SUBJECT: ISSUANCE OF AMENDMENT (TAC NO. 72962)

The amendment revises the Technical Specifications to permit reracking of the spent fuel storage pit with high density storage racks containing "Boraflex" as a neutron absorber. The high density storage racks will increase the spent fuel storage pit storage capacity from 980 to 1376 fuel assemblies. This change also increases the fuel enrichment from 4.3 w/o U-235 to 5.0 w/o U-235.

Amendment No. 150
License No. DPR-26

SAFETY EVALUATION BY THE OFFICE OF NUCLEAR REACTOR REGULATION
RELATED TO AMENDMENT NO. 150 TO FACILITY OPERATING LICENSE NO. DPR-26
CONSOLIDATED EDISON COMPANY OF NEW YORK, INC
INDIAN POINT NUCLEAR GENERATING UNIT NO. 2
DOCKET NO. 50-247

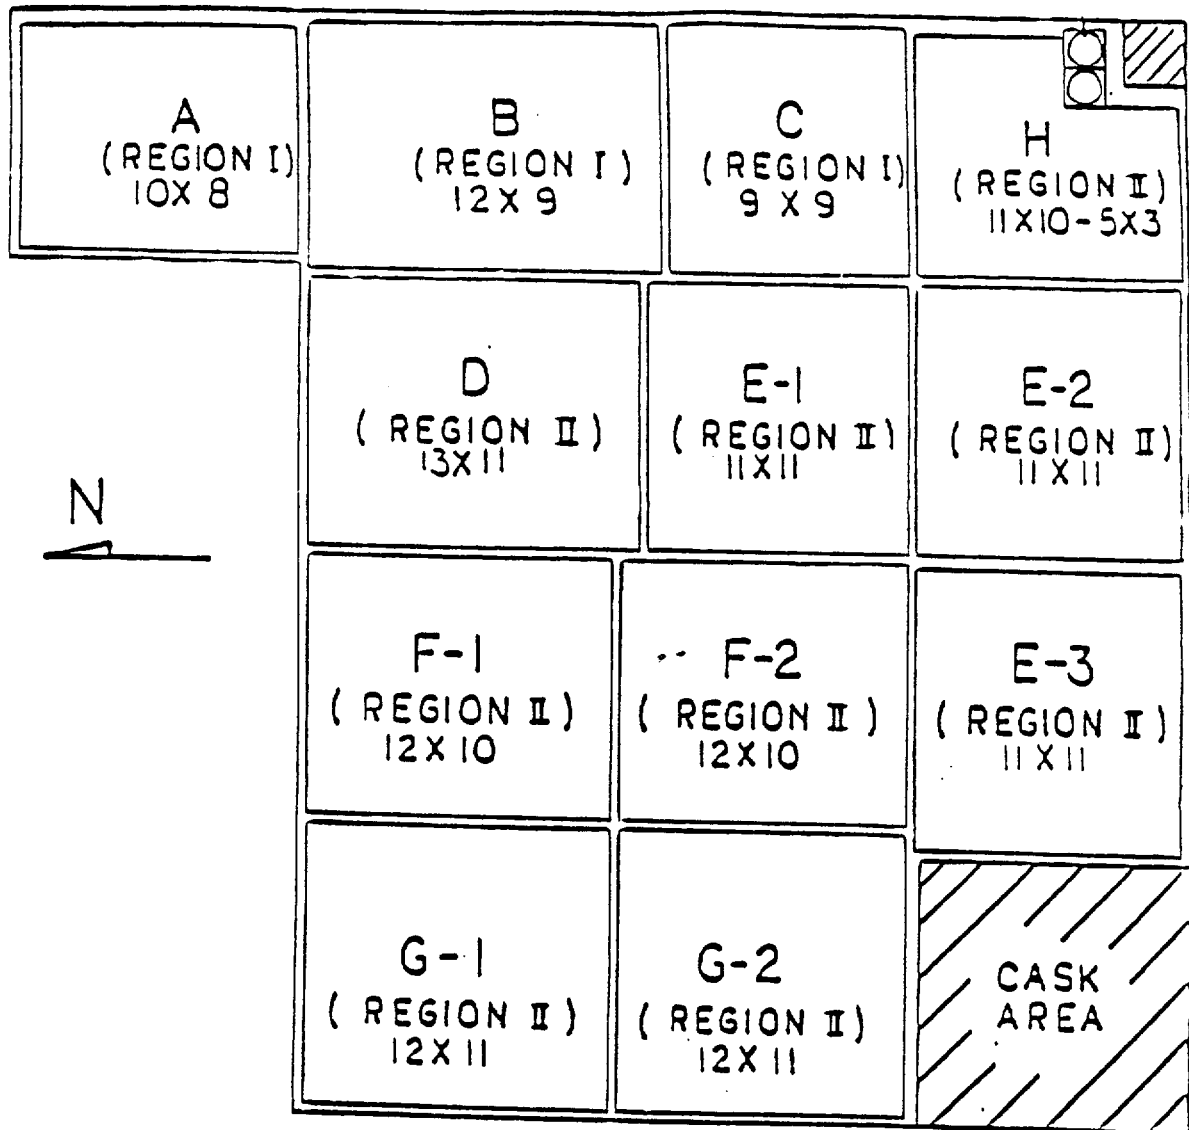
The fuel enrichment and burnup limits in Specification 3.8.D.1 and the boron requirements in Specification 3.8.D.2 assure the limits assumed in the spent fuel storage safety analysis will not be exceeded.

Spent Fuel Storage Rack Layout - IP2 Pool

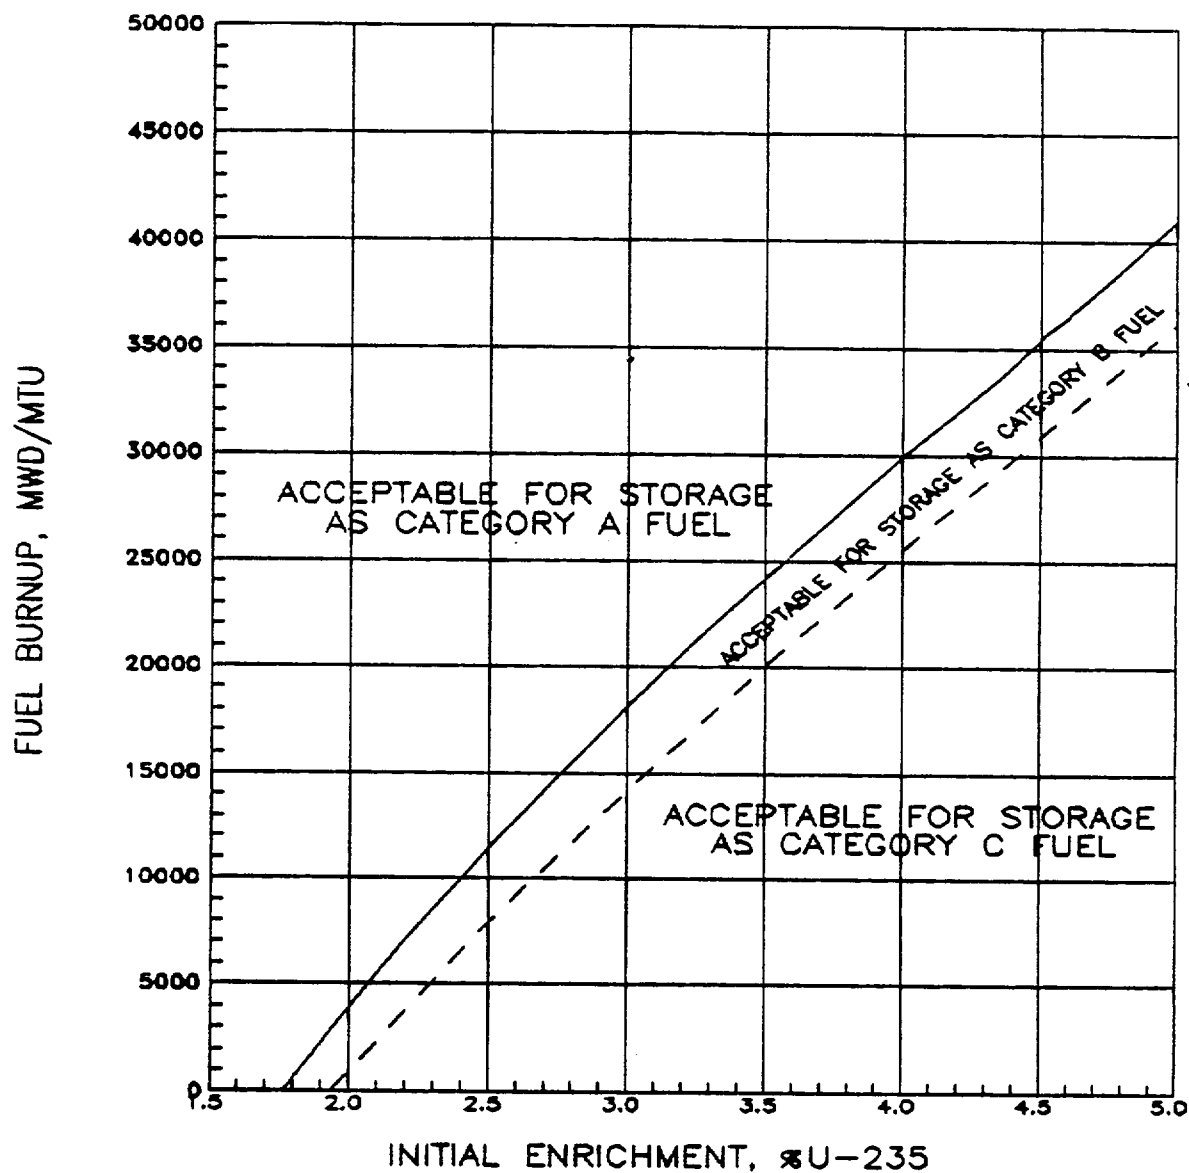
1. The spent fuel storage racks are categorized as either Region I or Region II as specified in Figure 3.8-2. Fuel assemblies to be stored in the spent fuel storage racks are categorized as either Category A, B or C based on burnup and enrichment limits as specified in Figure 3.8-3. The storage of Category A fuel assemblies within the spent fuel storage racks is unrestricted. Category B fuel assemblies shall only be stored in Region I or in a Region II spent fuel rack cell with one cell wall adjacent to a non-fuel area (a non-fuel area is the cask area or the area on the outside of a rack next to a wall). Category C fuel assemblies shall be stored only in Region I. The one exception to this shall be fuel assembly F-65 which shall be stored in Region I or in a Region II spent fuel rack cell with two cell walls adjacent to non-fuel areas.

TS 3.8.D.3 replaces TS 5.4.3 which specified that, with fuel in the spent fuel pit, the spent fuel pit boron content must be equivalent to that in the refueling canal and reactor cavity during refueling operations. Note that TS 3.8.D.1 includes Figure 3.8-2 which shows the spent fuel and the classification required for storage in each rack.
